**SAS SUPERSTRUCTURE - CONDUIT AND CABLE TRAY PLAN**

CONTRACT CHANGE ORDER NO. 42  
 SHEET \_\_\_\_ OF \_\_\_\_

**SAS SUPERSTRUCTURE GIRDER EASTBOUND LIGHTING AND ELECTRICAL SYSTEMS**

**E-184**

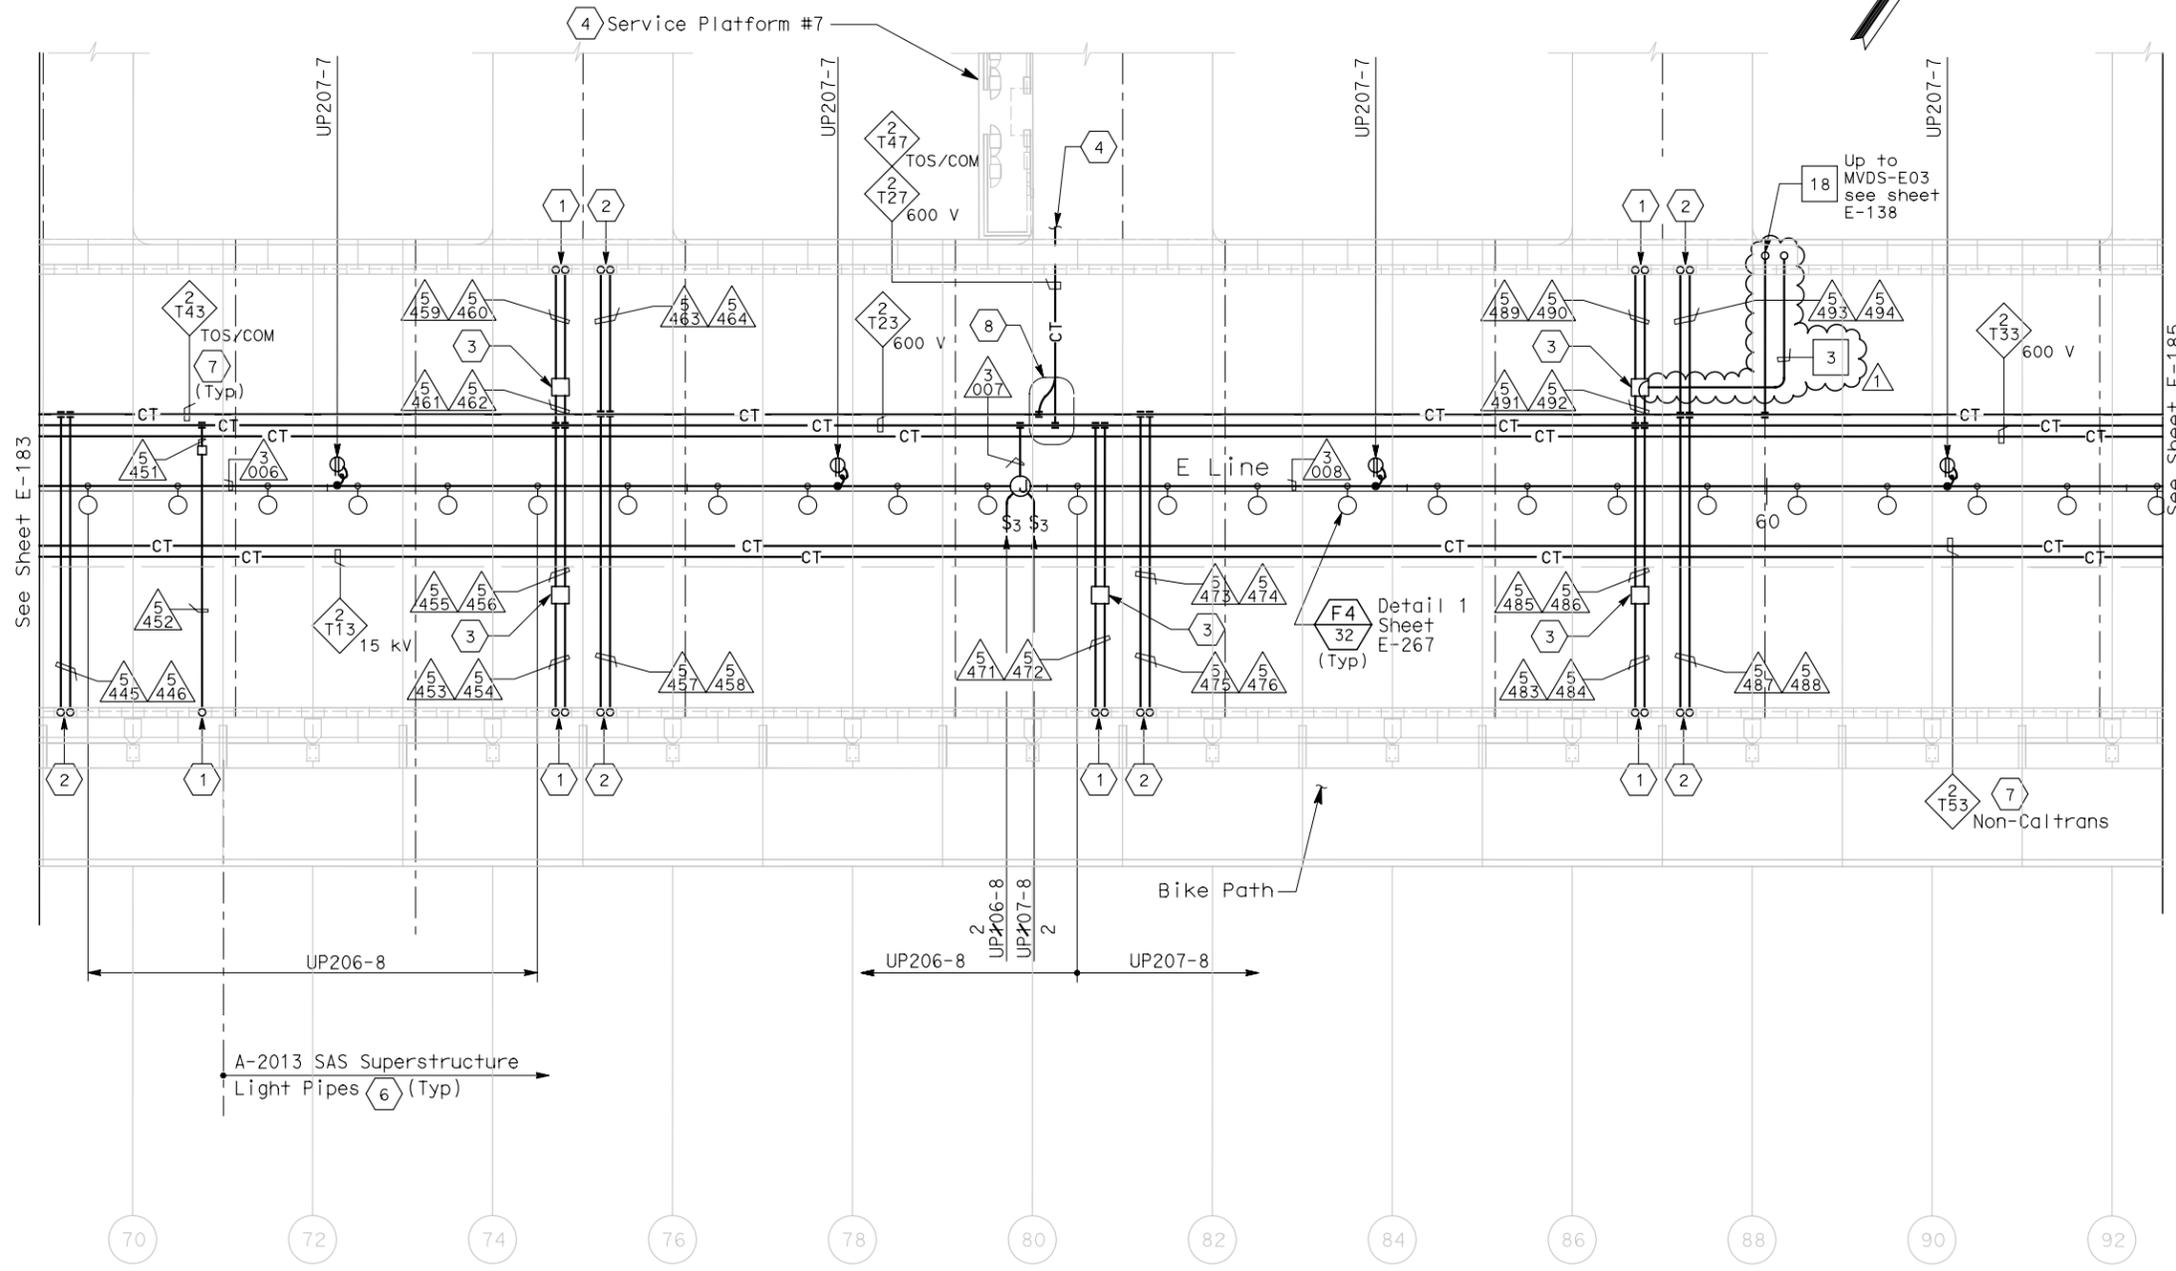
MARK	DATE	DESCRIPTIONS	BY	CK	CCO
1	8-06-07	Electrical modifications.	MP	RR	42
REVISIONS
